Access Compliance Report

Public Rights-of-Way

Intersection ID: 5940	Main Street: UNIVERSITY_EXECUTIVE_PARK_DR	Cross Street: MCCULLOUGH_DR	Location: NE
ADA ID: 75EABED74304	Ramp Type: Perp	Initial Pass/Fail: Fail	Overall Compliance: No
Codes/Mitigation Info/Possible Solution		Field Measurements/Component Compliance	
Severity Score: 21.25

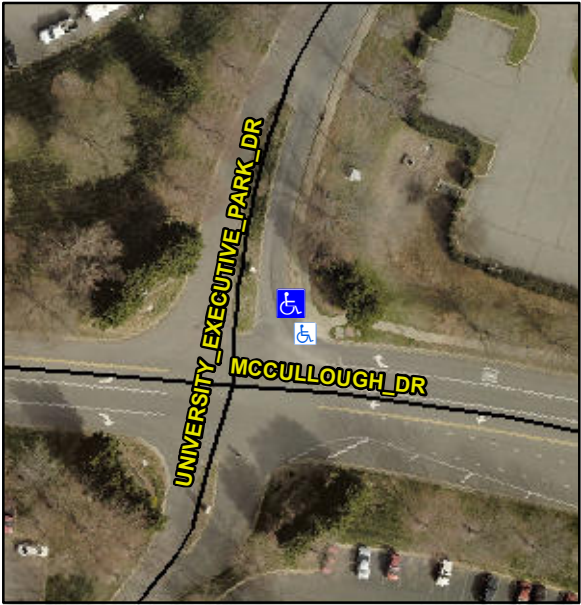
Possible Solutions:						
	Remove & Replace Entire Ramp.	N/A	Ramp Length (in)	63.0	No	Ramp Slope (%)	10.4
		No	Ramp Width (in)	43.0	Yes	Ramp XSlope (%)	1.6
		N/A	Flare Type LT	N/A	N/A	Flare Type RT	N/A
		N/A	Flare Slope LT (%)	N/A	N/A	Flare Slope RT (%)	N/A
		N/A	Flare Traversable LT?	N/A	N/A	Flare Traversable RT?	N/A
		N/A	Landing Length (in)	N/A	N/A	DWS Provided?	N/A
		N/A	Landing Width (in)	N/A	N/A	DWS Contrast?	N/A
		N/A	Landing Slope (%)	N/A	N/A	DWS Length (in)	N/A
		N/A	Landing X Slope (%)	N/A	N/A	DWS Full Width?	N/A
<p>Surveyor Notes:</p> <p>N/A</p> <p>PROW/ADA:</p> <p>Not Found, R304.5.1, R304.2.2</p>		N/A	Landing Curb? (Y/N)	N/A	N/A	DWS Offset (in)	N/A
		N/A	Shared Landing?	N/A			
		N/A	Gutter Ponding?	N/A	N/A	Gutter Slope (%)	N/A
		N/A	Gutter Lip Ht (in)	N/A	N/A	Gutter X Slope (%)	N/A
		N/A	Painted X Walk1?	No	N/A	Painted X Walk2?	N/A
			X Walk 1 Direction	To W		X Walk 2 Direction	N/A
		N/A	X Walk 1 Width (in)	N/A	N/A	X Walk 2 Width (in)	N/A
